New high limit controller connections

When replacing a High Limit controller that had a contact #7 by the newer controller that does not have the #7 contact.

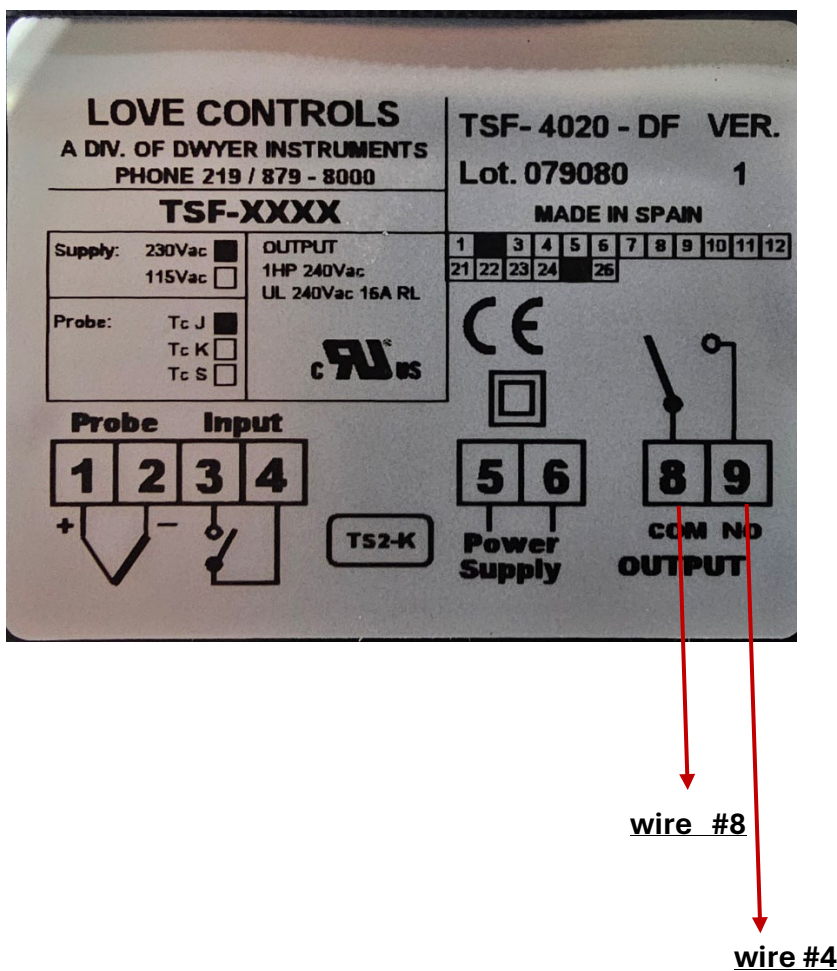
See below on how to connect the new model. **Please note that wire #9 will be left disconnected**

***** wire #9 needs to be left disconnected*****

Please note that the other contacts are wired the same way as they were on the older High Limit controller version.
